Revised Decision Letter

Subject: LDC16-00060 (Record Street Brewing Co.)
APN No. 007-313-21

Master Plan Application – Administrative Determination

Minor Modification (to existing approval)

Figure 2. E. 4th Street (street view)

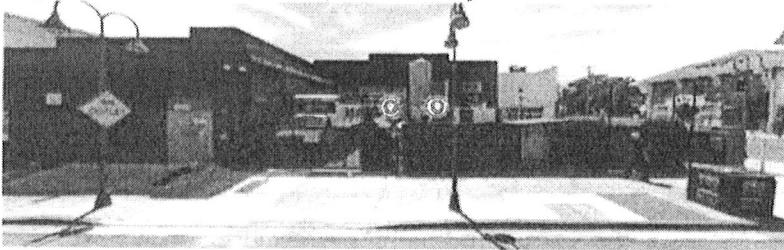
2. Request for minor modification to LDC 16-00060 to remove street tree installation requirement from condition 10.

Applicant feels that the safety/security concerns expressed by the prior tenant/licensee remain in place today and is requesting that the street tree requirement be removed from condition 10 of LDC 16-00060 until such time that the safety and crime threat has been mitigated in this area.

10. Prior to the issuance of a building permit, plans shall be approved to include a minimum 100 square feet of landscape area within the outdoor patio area. ~~A street tree shall be installed on Record Street to the approval of the Urban Forester.~~
